U.S. Department
of Transportation

Federal Railroad
Administration

Reply to Attn of: MP& E 00-06

Subject: Manufacture and repair of operating platforms and operating platform safety railings on tank cars without underframes.

STANCHION TO RAILING ATTACHMENT OPTIONS

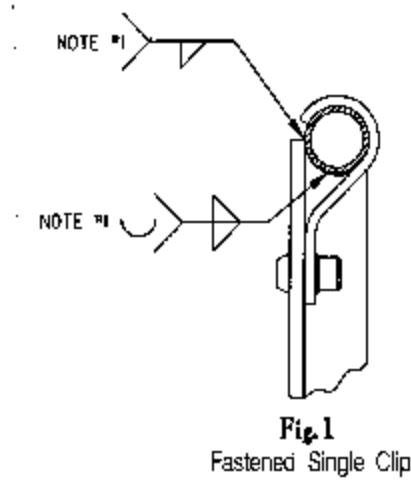
NOTE #1: Welding in addition to Mechanical Fasteners is acceptable at the option of industry. Additional fasteners are acceptable.

ATTACHMENT TO GRATING AT INTERMEDIATE LOCATIONS

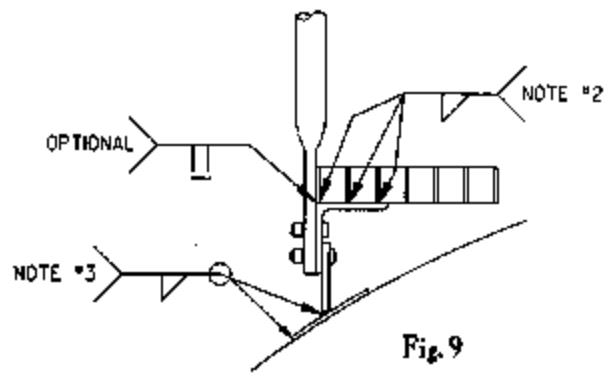
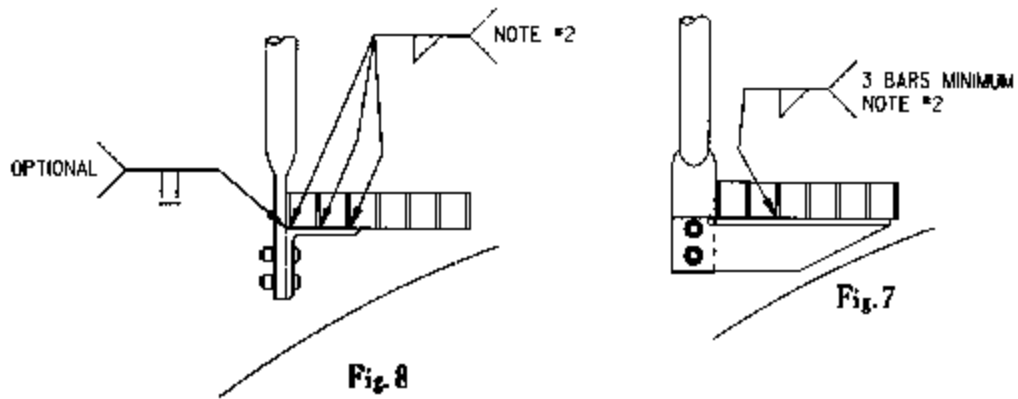
FRA will exercise its enforcement discretion and not take exception to the factory weldment of safety appliance brackets at intermediate locations on the grating of operating platforms. See Exhibits A and D, Figures 7 through 9. There are several reasons for this exercise of discretion. The gratings used on operating platforms have been manufactured for years with these intermediate brackets being directly welded to the gratings, and FRA is not aware of any safety hazards arising from this design. Furthermore, due to the high quality of factory welds, a mechanical fastener would add little or no structural strength to the attachment. In addition, this type of weldment will be permitted only on intermediate brackets, where less stress is being placed on the attachment. All platform attachments at end supports will be required to be mechanically fastened. See Exhibits A and C, Figures 6 and 6A. Moreover, the only field repair that will be permitted on intermediate brackets will be replacement of the grating assembly with a factory-made assembly or application of mechanical fasteners. See Exhibits A and D, Figures 7 through 9.

NOTE #2: Factory Welds or Mechanical Fasteners are acceptable securement at these locations. Field repairs require Mechanical Fasteners or Factory Assemblies.

NOTE #3: Field welding acceptable at these locations.

Fig. 13
Typical
Reinforcement Insert
where Flattened

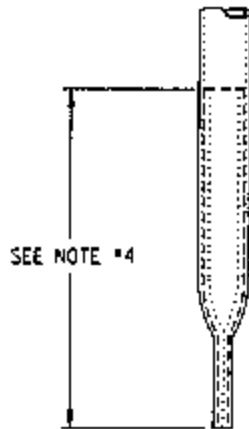
NOTE #4: When safety railing is 1 1/4 inch pipe and involves flattening, pipe must be reinforced with a steel pipe insert at least 11 inches long or twice the length of the flattened portion, whichever is greater.

Fig. 14
Typical Repair
See Note 5

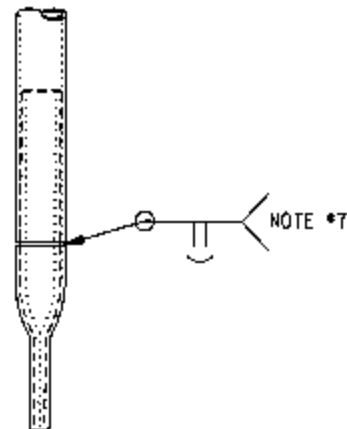
NOTE #5: Repair in accordance with AAR Interchange Rule 81 Figure 81, 1999 revision, attached.

Fig. 15
See Note 6

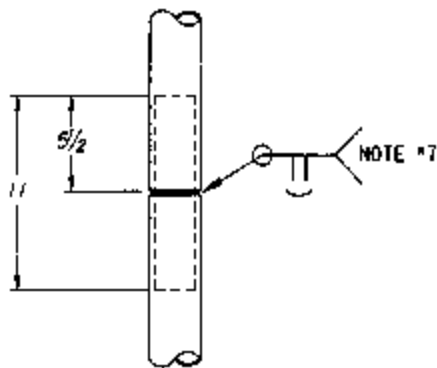
NOTE #6: In Accordance with 6/28/96 FRA Letter to UTC and sketch x-6994.

Fig. 17

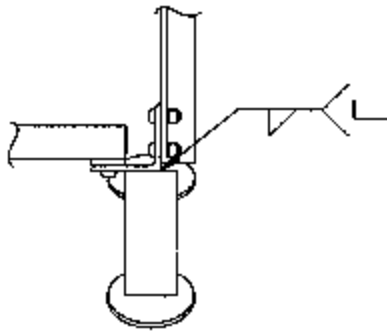
*ATTACHMENTS APPROVED ONLY FOR
EXISTING CARS BUILT PRIOR TO JAN. 01, 2000

Stanchion to Bracket Attachment*

See Note 8

NOTE *8: Field repairs require mechanical attachment similar to Figure 6.

Fig. 18

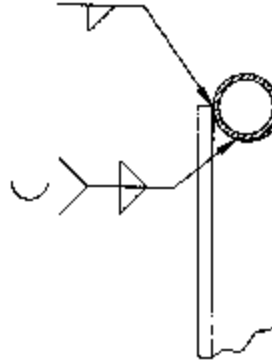
Railing to Stanchion Attachment;
AJ-Welded*

See Note 9

NOTE *9: Field repairs require mechanical fasteners similar to Figures 1 thru 3.

FIGURE A

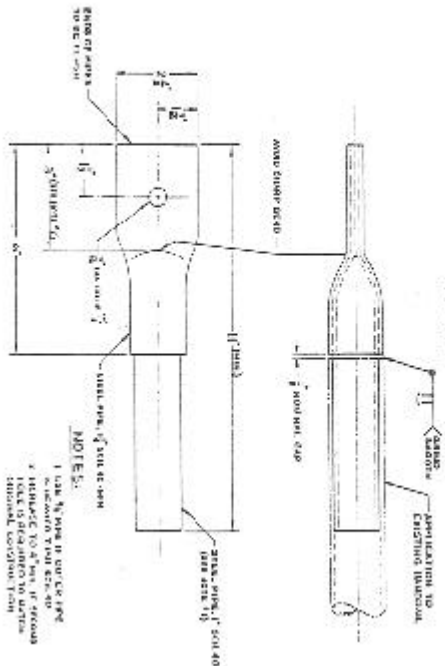
3. Welding is not permitted to the following:
 - a. Tank car end platform safety railings, side railings, or operating platform safety railings, all other than as guards, except as shown in Figure A, or as provided for in the original approved design.
